Technical Service Bulletin

GROUP CAMPAIGN	NUMBER 16-01-013
DATE MARCH 2016	MODEL(S) SANTA FE SPORT (AN)

SUBJECT: SANTA FE SPORT DRIVER SEAT BELT BUCKLE HARNESS
(RECALL CAMPAIGN 141)

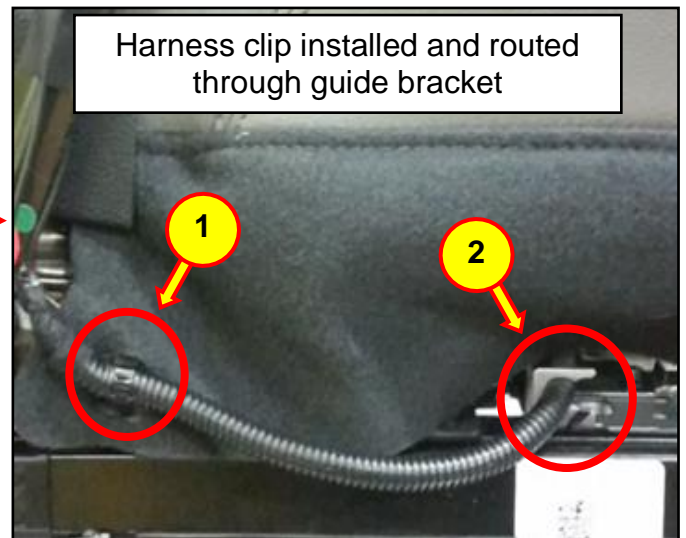
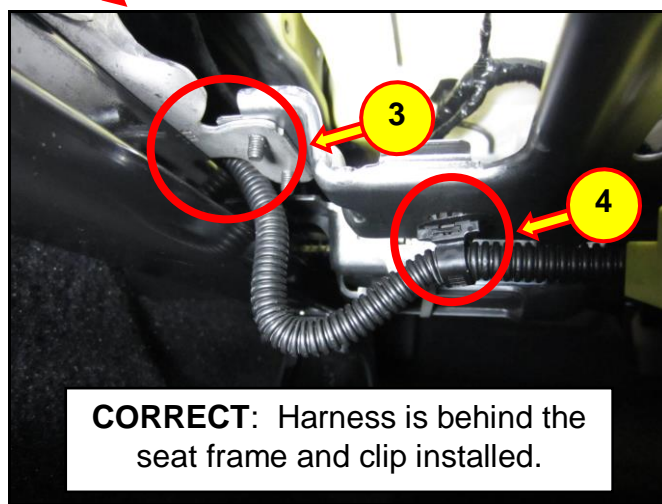
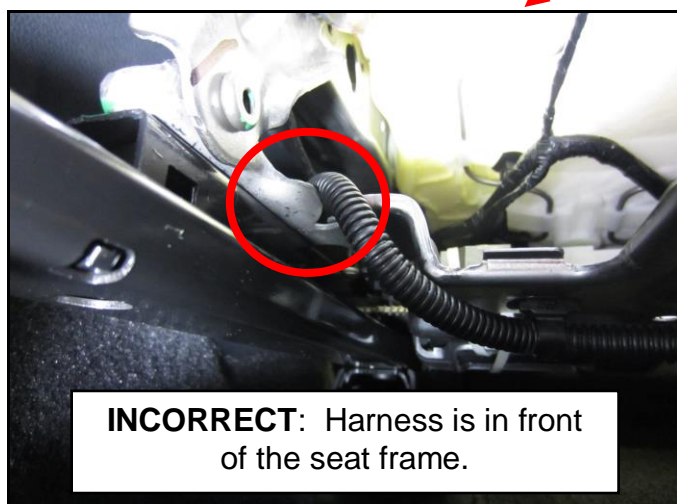
2. Check if the buckle wiring harness is correctly routed and clips are securely attached by inspecting the below positions. If the buckle harness routing is correctly routed, no further action is needed.

- 1 Harness clip installed to seat (inboard side of seat).
- 2 Harness routed through guide bracket (inboard side of seat).
- 3 Harness routed behind seat frame (under seat).
- 4 Harness clip installed (under seat).

- 3. If the buckle harness is not installed correctly, inspect for wire damage.

- 4. If harness is only misrouted and not damaged, follow the Rerouting Procedure on page 5 of this TSB.
- 5. If the harness wire is damaged, replace the buckle by following the Replacement Procedure on page 8 of this TSB.
